The Role of Background O₃ in the NAAQS Review

George T. Wolff, Ph.D.

For the Utility Air Regulatory Group
and

The Alliance of Automobile Manufacturers

Source: U.S. EPA Second Draft PA, Figure 2-14

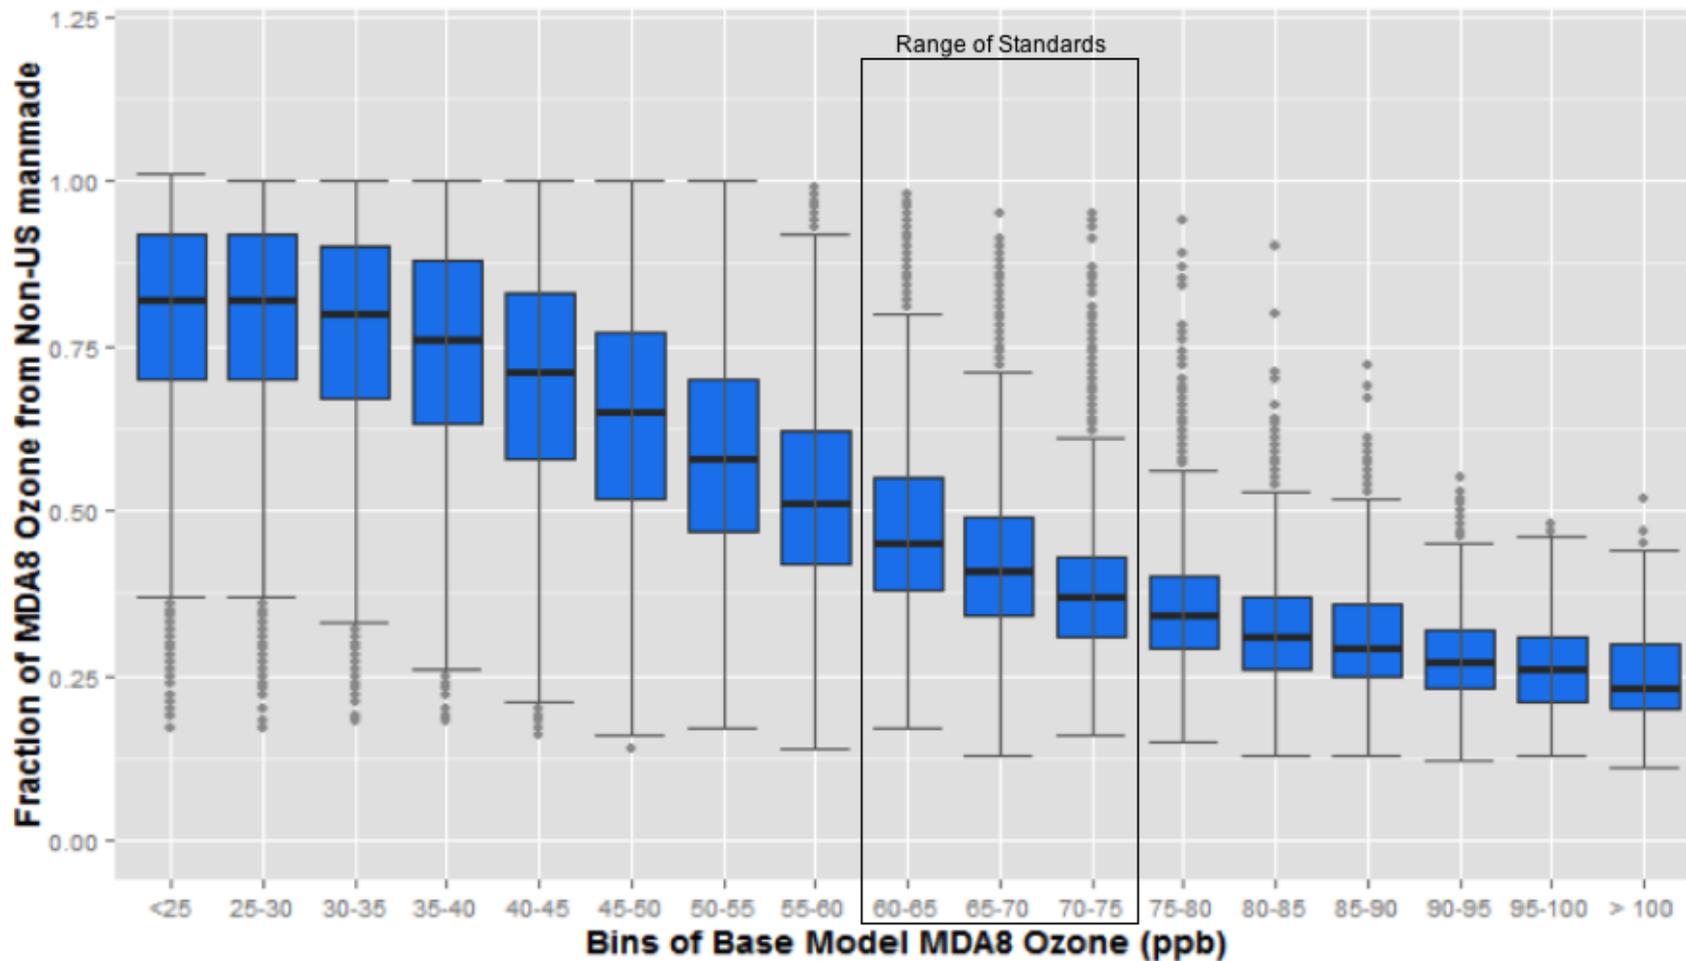
Even though EPA's USB estimates are biased low, they are significant

Despite the significant contribution of USB to MDA8, EPA ignores USB in the health risk assessment as they estimate risk to zero O_3
